City of Sandy

Planning Commission Meeting

- 7.1. 21-021 SUB/VAR/TREE/HD The Bornstedt Views Subdivision 12 - 970
[21-021 SUB VAR TREE HD The Bornstedt Views Subdivision - Pdf \(1\)](#)
[Exhibit A - Land Use Application - The Bornstedt Views](#)
[Exhibit B - Narrative - Supplemental Narrative - The Bornstedt Views](#)
[Exhibit C - Civil Plans - The Bornstedt Views](#)
[Exhibit D - Storm Drainage Report - Bornstedt Views](#)
[Exhibit E - Traffic Impact Study - Bornstedt Views -Final and Stamped \(May 23, 2022\)](#)
[Exhibit F - Arborist Report - Updated - Bornstedt Views \(April 29, 2022\)](#)
[Exhibit G - Stream and Wetland Determination - Updated - Bornstedt Views \(April 29, 2022\)](#)
[Exhibit H - Geotech Report - Updated - Bornstedt Views \(April 29, 2022\)](#)
[Exhibit I - Geotech Supp Review Letter- Updated - Bornstedt Views \(April 29, 2022\)](#)
[Exhibit J - Survey Map - SN2022-026](#)
[Exhibit K - Email from City Engineer - Bornstedt Views \(April 29, 2022\)](#)

PROJECT: **THE BORNSTEDT VIEWS TOPOGRAPHIC SURVEY**

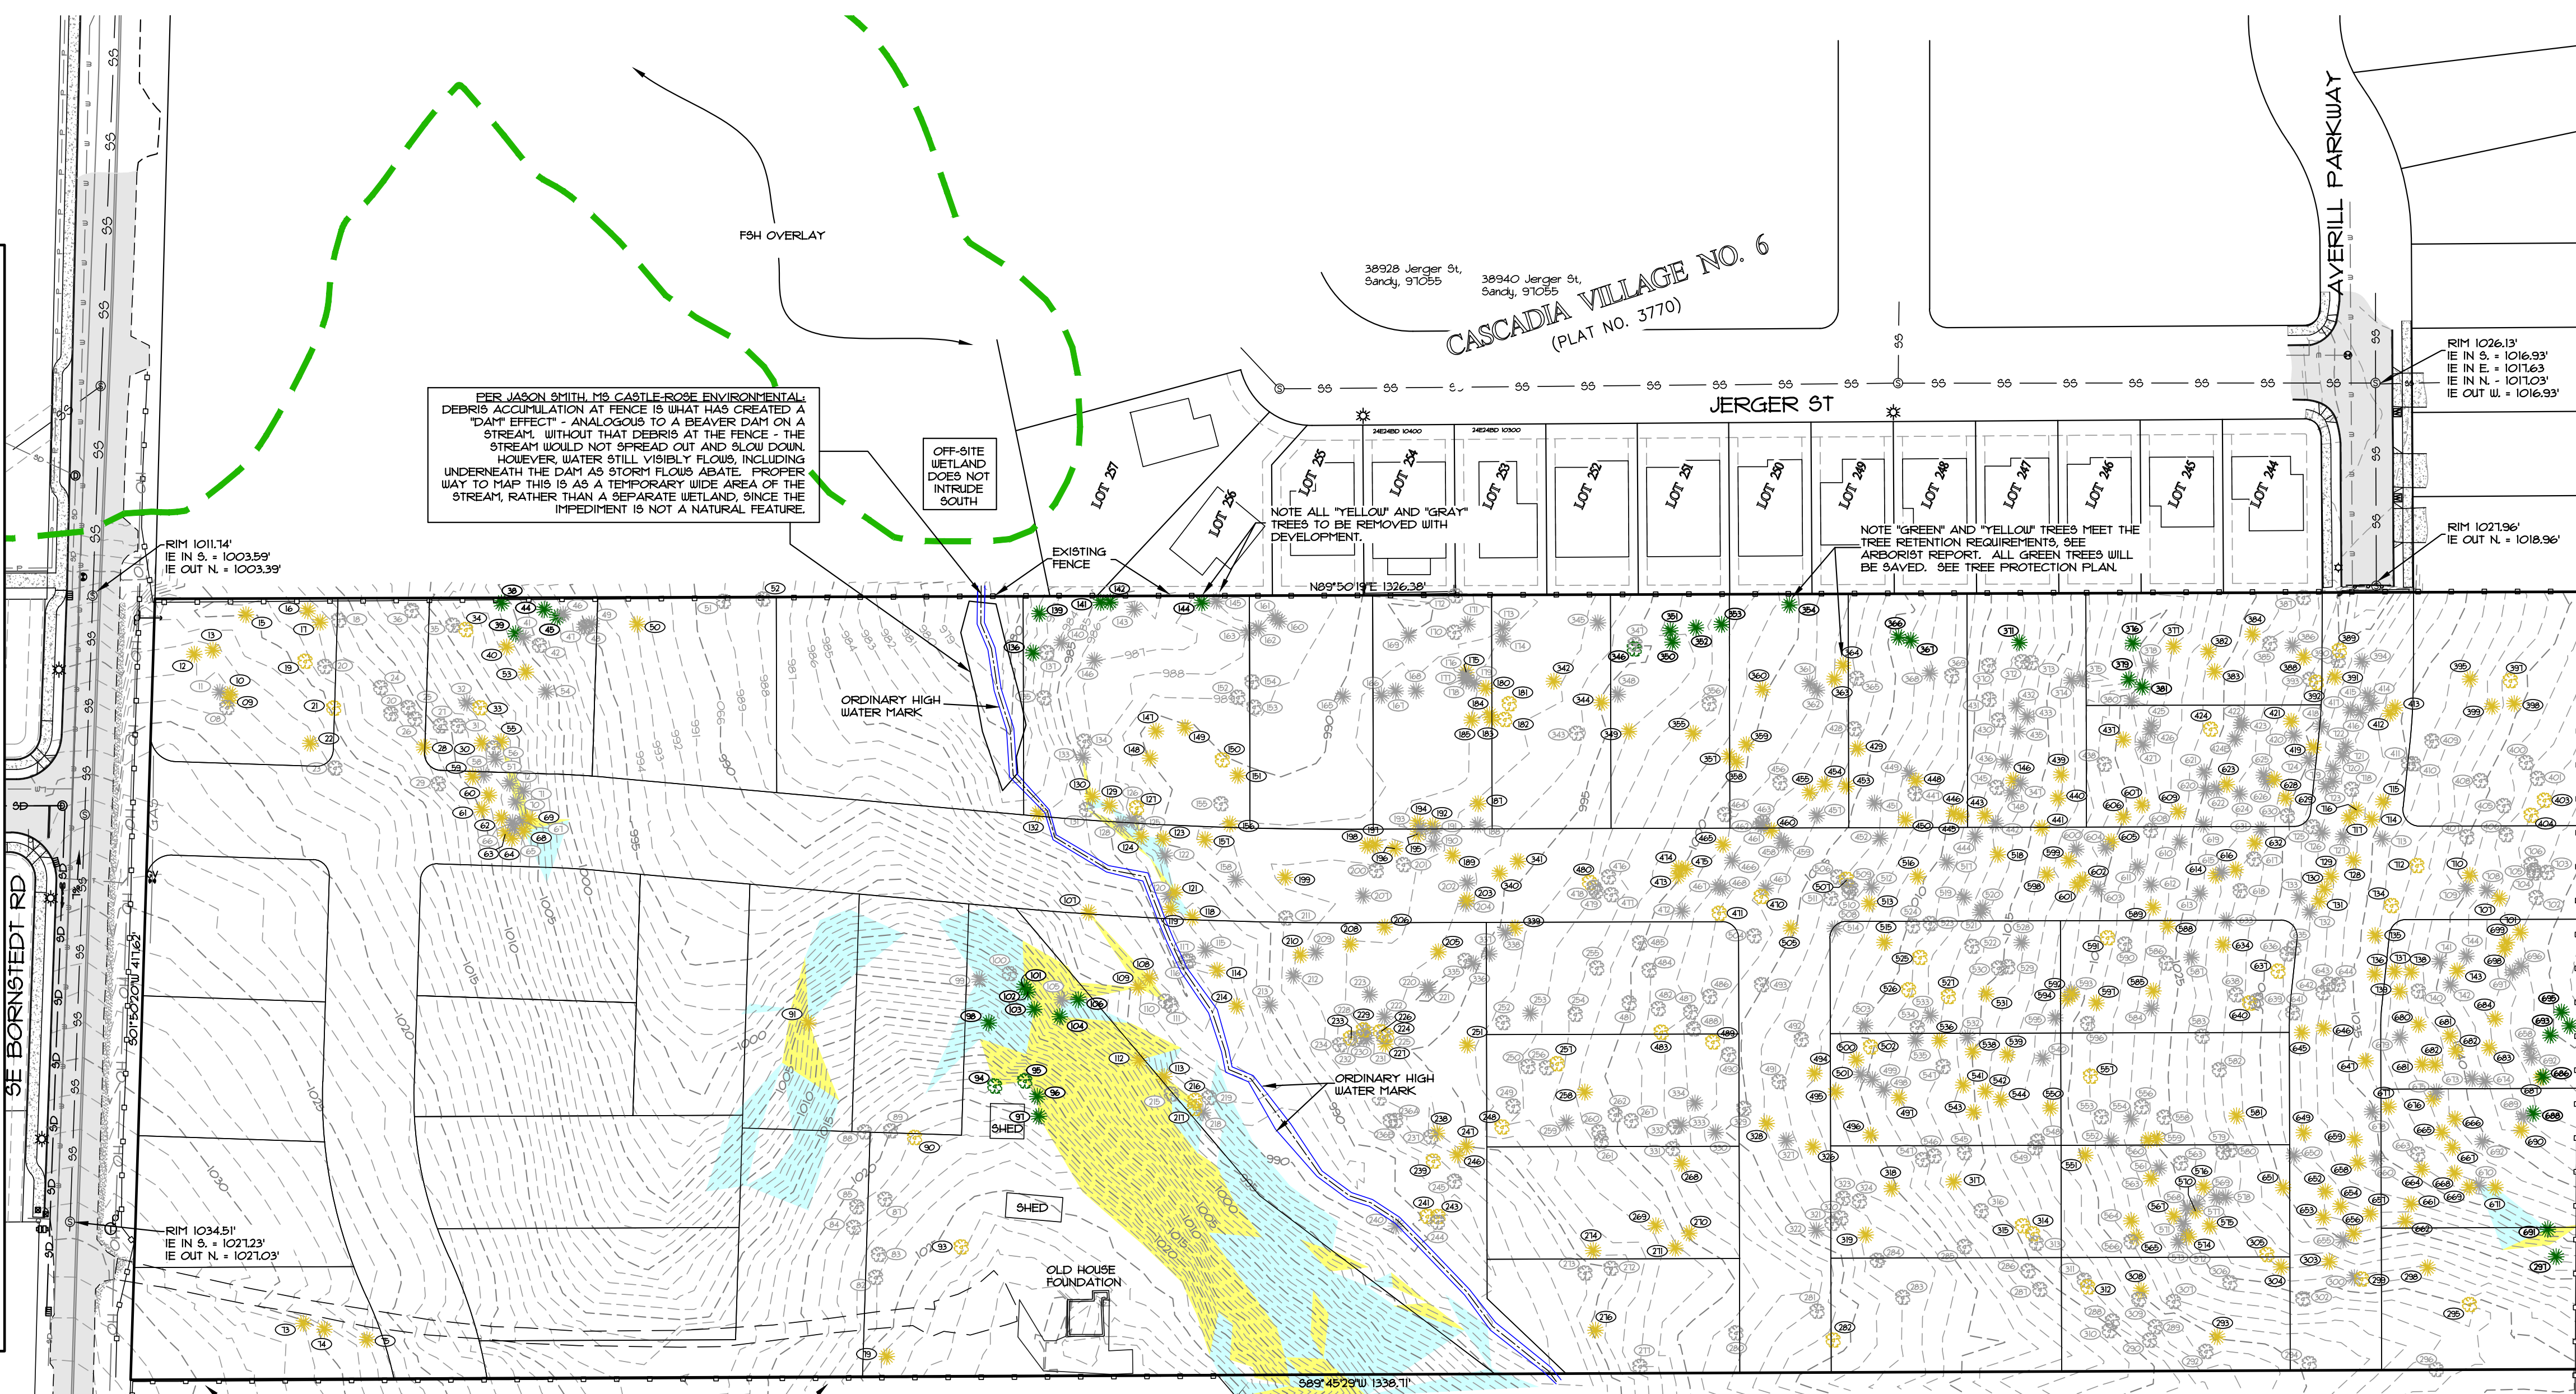
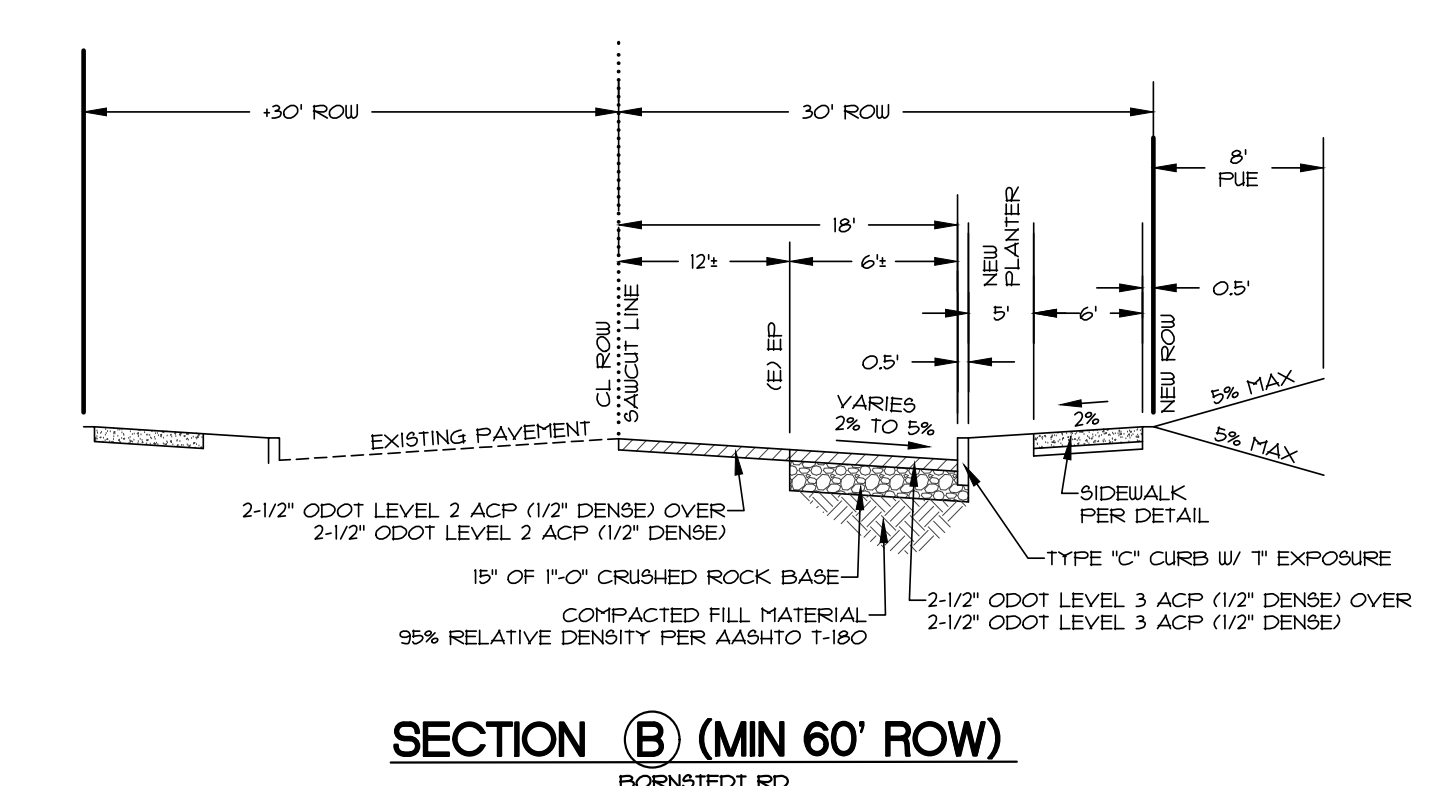
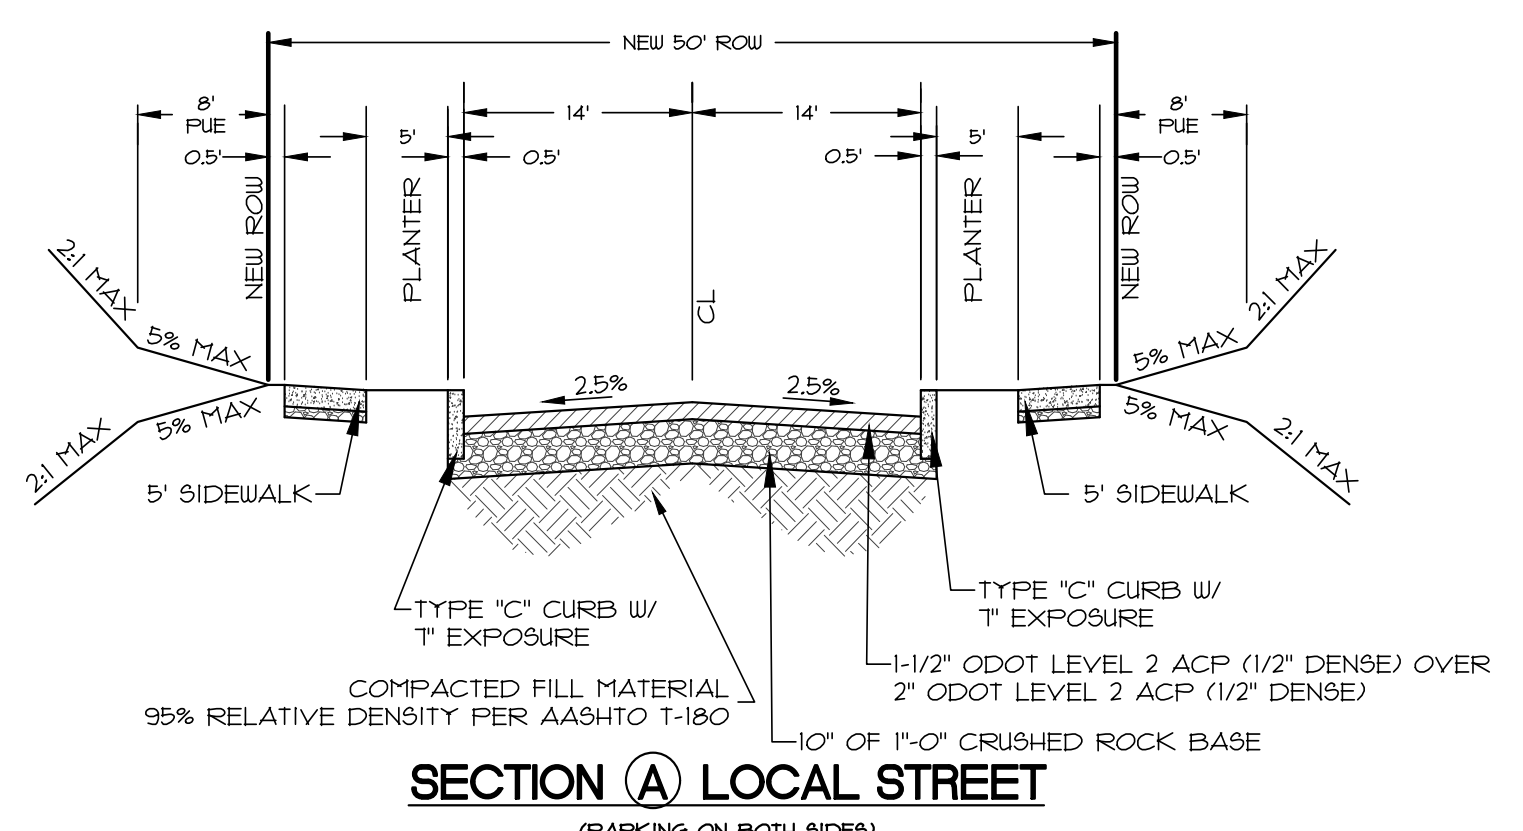
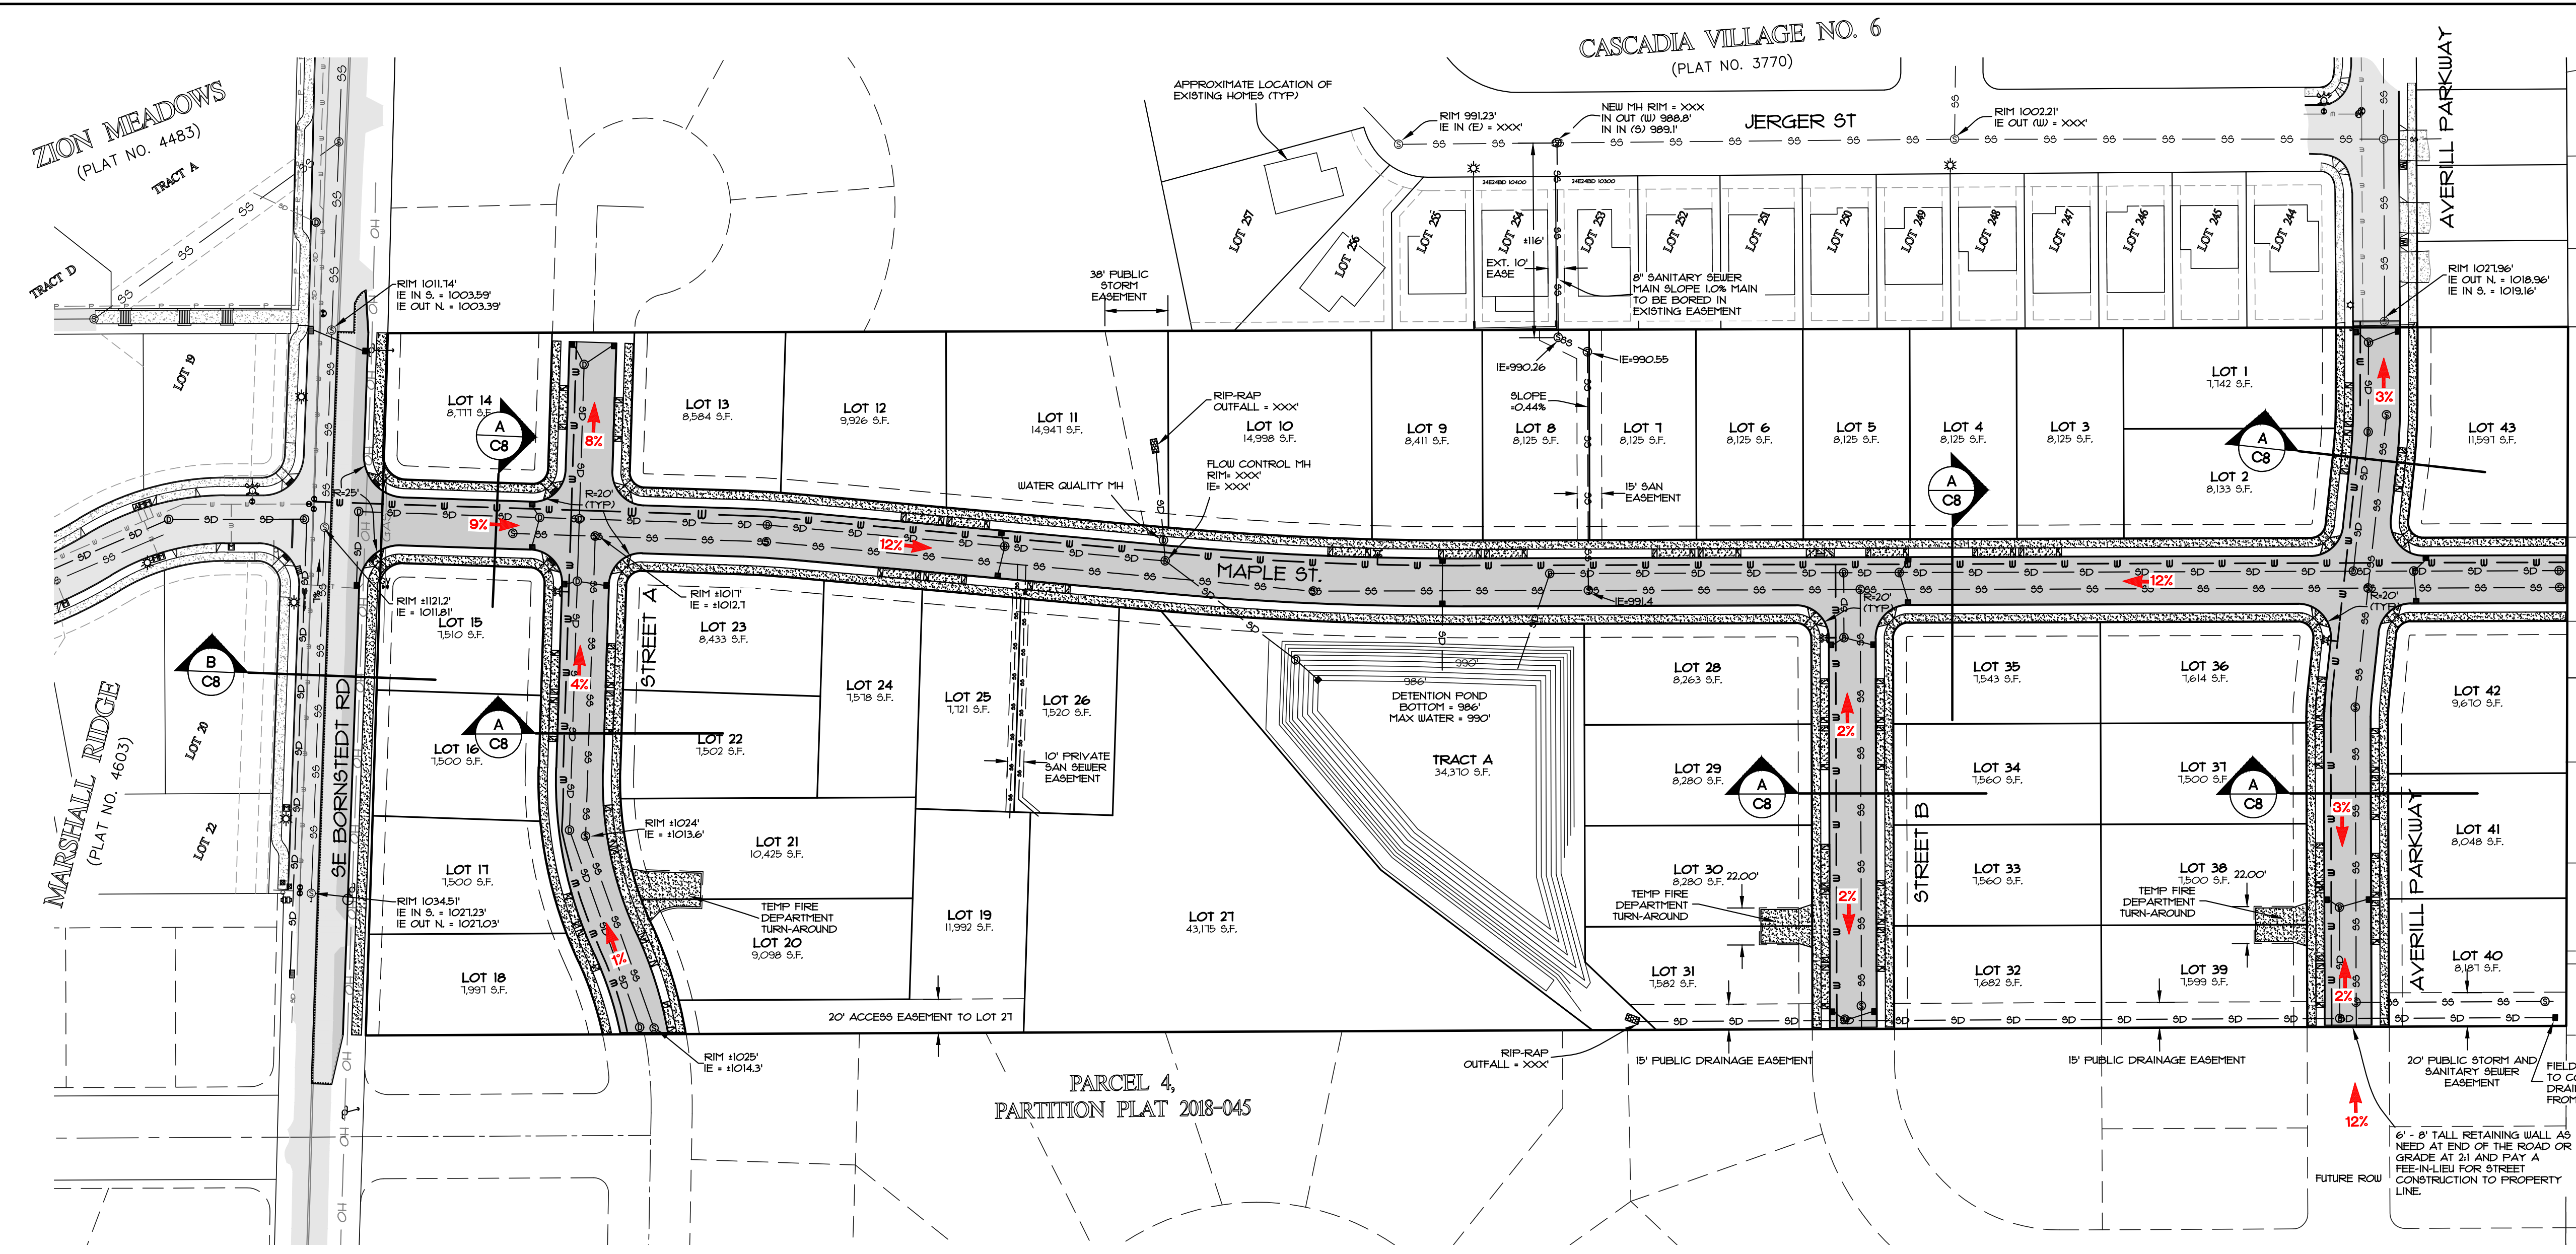
99. The Topographic Survey (Exhibit C, Sheet C3) details several trees proposed for removal that are located in close proximity to trees proposed for retention. These include trees located at the rear of Lots 1, 3, 4, 5, 6, 10, 13, 40, 41, and 42 and trees located at the front of Lot 27 (which staff recommends be protected as a tract). Staff expects that the lot numbers with retention trees will change based on the updated arborist report and tree protection plan. **Staff recommends all trees within the critical root zones of retention trees be left as snags rather than completely removed in order to minimize negative impacts to the remaining retention trees. If the applicant does not retain the trees proposed for removal from within the critical root zones of protected retention trees as snags, those trees shall be removed in a way that does not harm or damage adjacent trees. Tree removal and/or snag creation shall be completed without the use of vehicles, or heavy equipment in the tree protection zone. Trunks and branches of adjacent trees shall not be contacted during tree removal or snag creation. If the trees proposed for removal from within the critical root zones of protected retention trees are removed, their removal shall be completed under the supervision of the project arborist and the applicant shall fell the trees to be removed away from the trees to be retained so they do not contact or otherwise damage the trunks or branches of the trees to be retained. The applicant shall submit a post-construction report prior to plat recording prepared by the project arborist or other TRAQ qualified arborist to assess whether any of the retention trees**
